Walter E. Deuchler
Associates, Inc.
CONSULTING ENGINEERS

MEMORANDUM

RE: Stafford Place Development, Warrenville, IL

As requested, we have completed a review of the following documents:

VCBMP Treatment Area Map

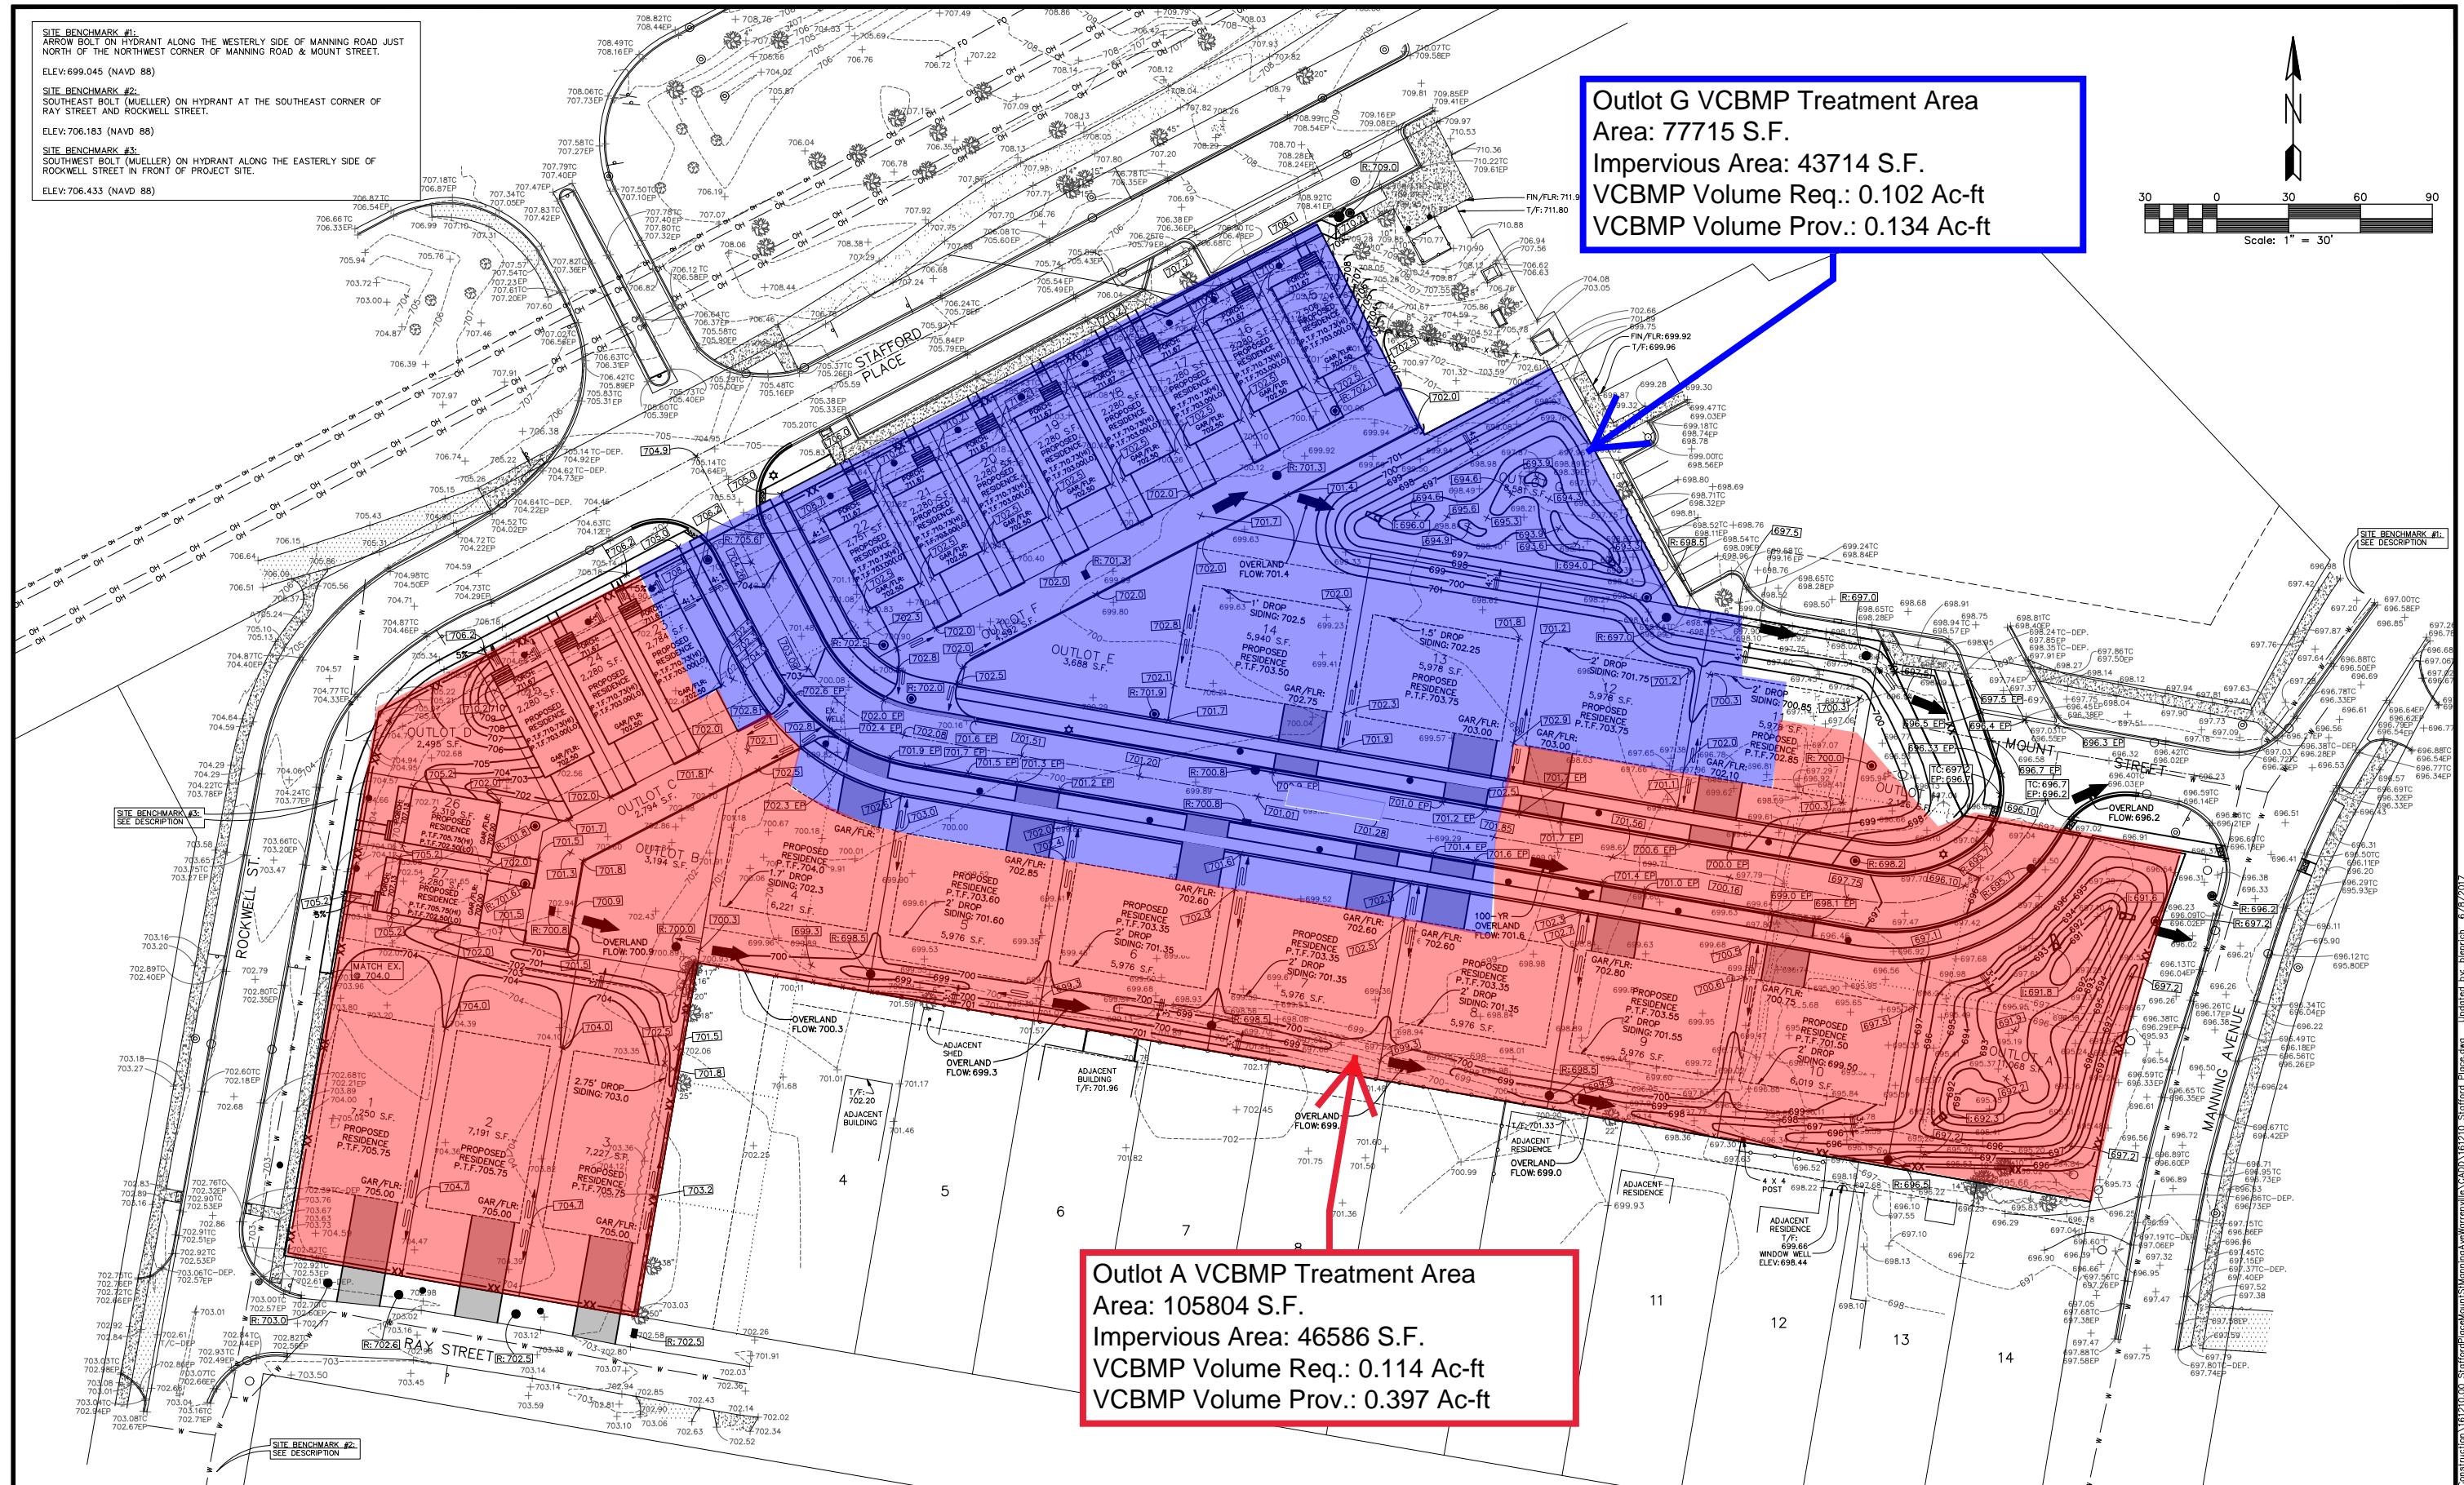
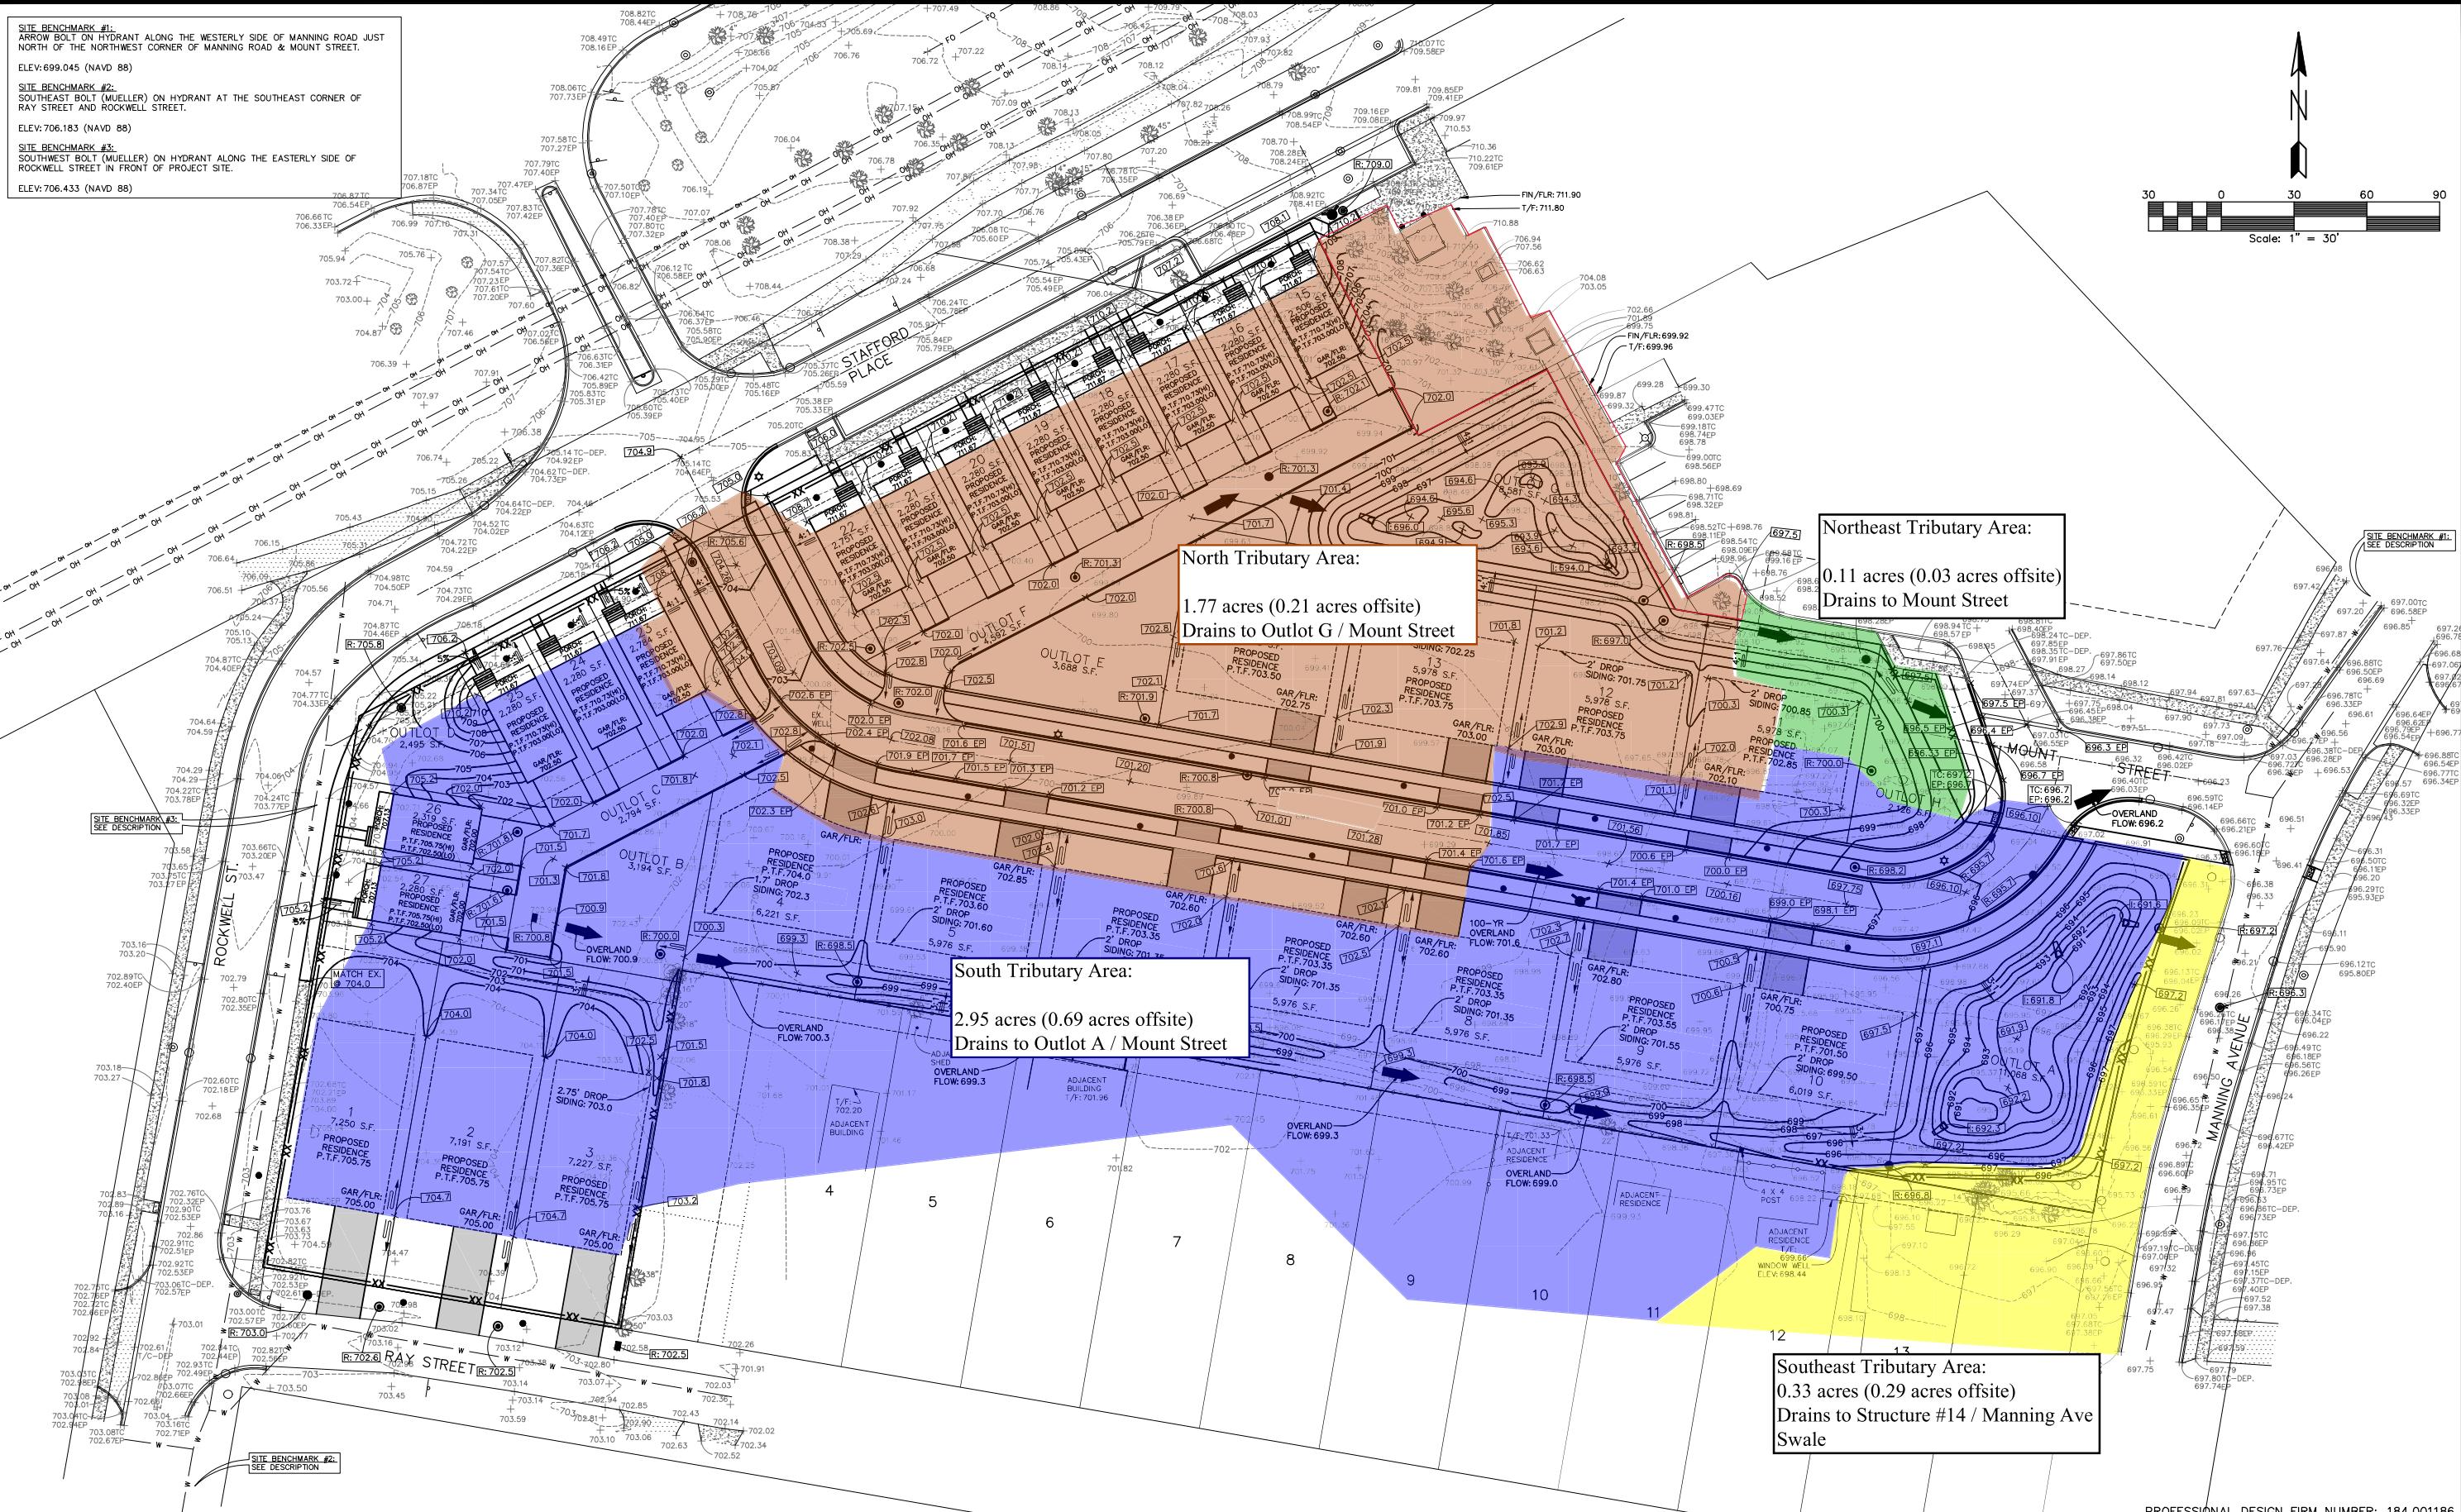
- **Post construction best management practices (PCBMPs) are required for the proposed development.** PCBMPs are required to treat the storm water runoff for pollutants of concern and to reduce runoff volume. Two natively-planted flow-through PCBMP basins are proposed: one at the northerly property line (Outlot G) and one at the easterly property line (Outlot A). These basins accept storm water from the impervious areas on site and route it through a meandering, natively-planted area. The plants slow the flow of water to allow for infiltration into the soil. The plants also allow for sediment and other contaminants in the water to settle out before entering the City's storm water system.

The PCBMP basins are designed to detain 1.25 inches of runoff over all new impervious area. They also contain restrictor outlet manholes to drain the runoff from the 2-year, 24-hour storm in a 48-96 hour period after the peak volume is stored in the basin. The proposed development has provided between 2.5 to 3.5 times more storage volume in these PCBMP basins than required by the DuPage County Stormwater Ordinance. See Attachment No. 3 for the proposed PCBMP calculations and tributary areas.
